DSOX4104A-01

S E R V I C E N O T E

4000 X-Series Scopes

A replacement of the power supply cover is needed when the cabinet assembly is replaced.

New revision cabinet assembly (54709-64401)

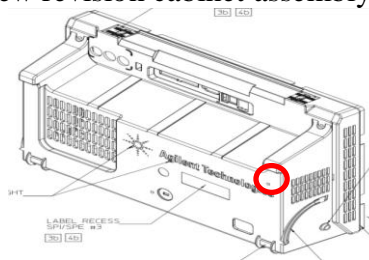
2. If the cabinet assembly is the new revision, proceed with repair as normal
3. If the cabinet assembly is the old revision
 - a. Replace the power supply cover (54695-00103) with new revision
 - b. Replace cabinet assembly as usual (54709-64401)
 - c. Insert screw (0515-0380) into the new screw hole on the cabinet assembly (circled below)
